UNITED STATES PATENT AND TRADEMARK OFFICE

APPLICATION NO.	FILING DATE	FIRST NAMED INVENTOR	ATTORNEY DOCKET NO.	CONFIRMATION NO.
10/594,315	06/27/2007	Lawrence C. Kennedy	032968-0134	2098

Office Action Summary	Application No. 10/594,315	Applicant(s) KENNEDY ET AL.	
	Examiner RYAN DODD	Art Unit 3655

DETAILED ACTION

Monroe '809 discloses, referring to Fig. 1, a viscous fluid clutch for use in a vehicle comprising:

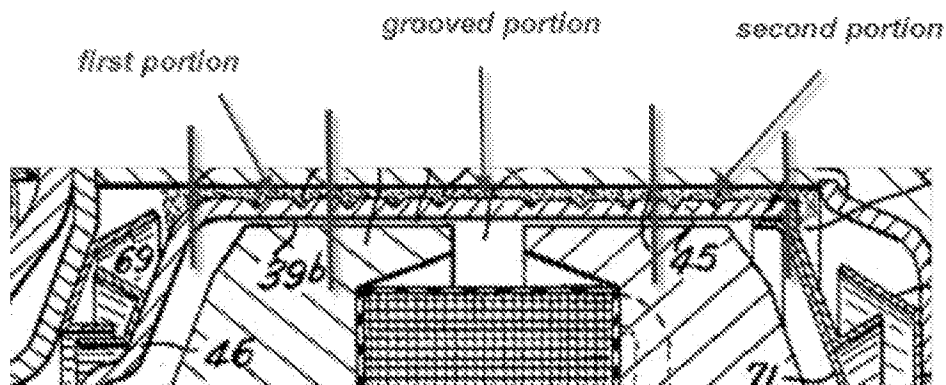
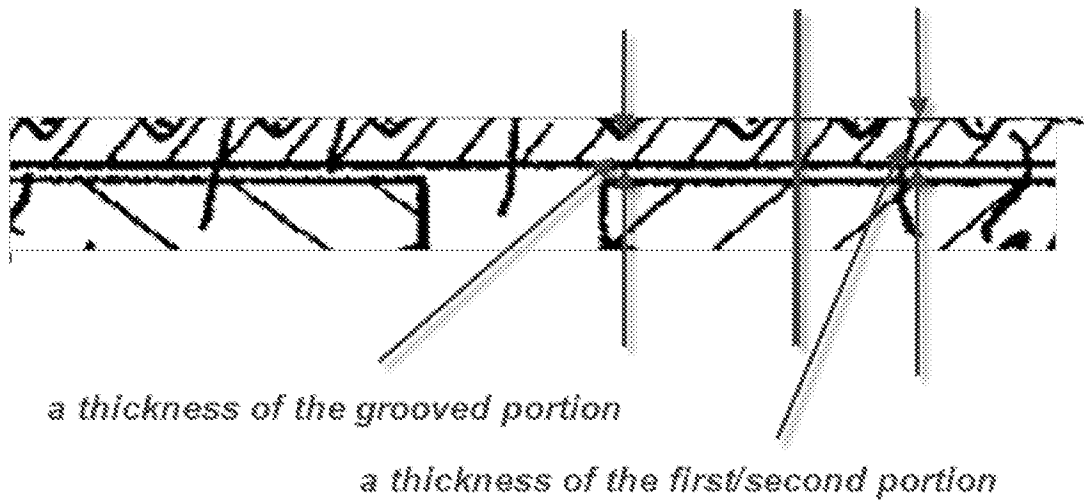
- a rotor (rotor 20) having a rotor hub (46) driven by an input shaft (input 21) and a rotor surface having an end connected to an outer periphery of the rotor hub,
- the rotor surface including: a first portion; a second portion; and a grooved portion disposed between the first and second portions (Fig. below);
- wherein the first portion, the second portion, and the groove portion are formed by a single piece,
- wherein the grooved portion forms a W-shaped profile (the grooved portion shown below and in Fig. 1 forms at least two W-shaped profiles),

- wherein the first and second portions of the rotor each have a thickness sufficiently greater than a thickness of the grooved portion (See Fig. below) such that a magnetic flux path in the fluid clutch will have a substantial portion of a magnetic field flow around the grooved portion as compared to a portion of the magnetic field flow that flows through the grooved portion.

In Monroe, the grooved portion has a thickness that appears to be about half as thick as a thickness of the first and second portions, which makes the thickness of the first and second portions in question sufficiently greater, even substantially greater than a thickness of the grooved portion.
